BANJO BRIEF

ISO Line Strainer Screen Color Change

ISO Standard 19732-2007

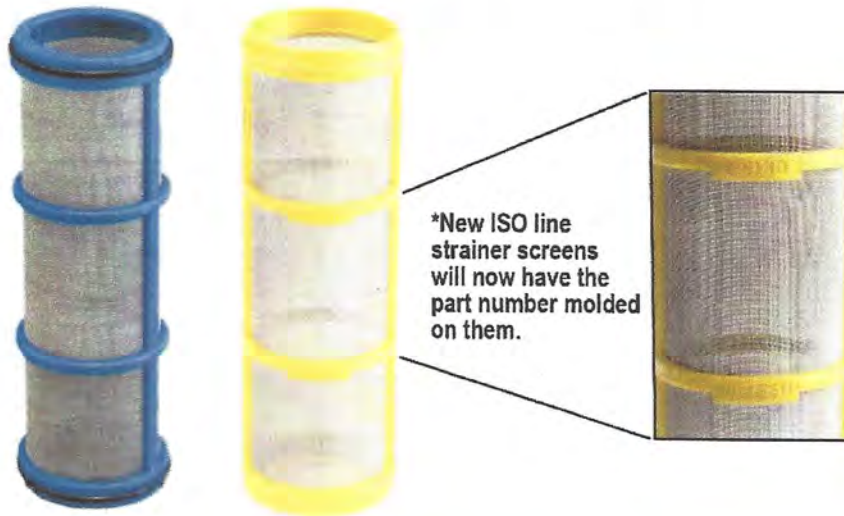
Banjo is changing the coloring scheme on our line strainer screens in accordance with ISO standard 19732-2007. This new color coding will align our screen colors to the colors used within the ISO standard. At the same time, *Banjo will print the part number and the mesh size on the plastic rib for quick and easy identification.*

Mesh screens that are affected by the ISO standard color changes are LS1##, LS2##, LS7##, LST1##, LST15##, LST5## part numbers.

Mesh Size	Old Color	New Color	RAL #
6	White	No Change	N/A
8	Blue	Zinc Yellow	1018
12	Black	No Change	N/A
16	Gray	Brown Red	3011
20	Beige	No Change	N/A
30	Yellow	Flame Red	3000
40	Brown	No Change	N/A
50	Red	Gentian Blue	5010
60	Orange	Gentian Blue	5010
80	Blue	Zinc Yellow	1018
100	Green	Traffic Green	6024
120	Black	No Change	N/A
150	White	Pure Orange	2004
